SITE PLAN REVIEW

LOT NO 23L REGISTERED PLANGS M - 4500

KLEINBURG GLEN VAUGHAN, ON

SITE PLAN

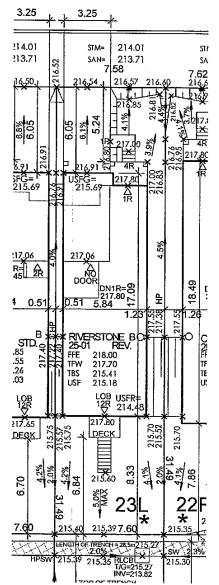
THE PROPOSED LOT GRADING AND DRAINAGE IS APPROVED AS BEING IN CONFORMITY WITH THE OVERALL APPROVED GRADING PLANS FOR THE SUBDIVISION.
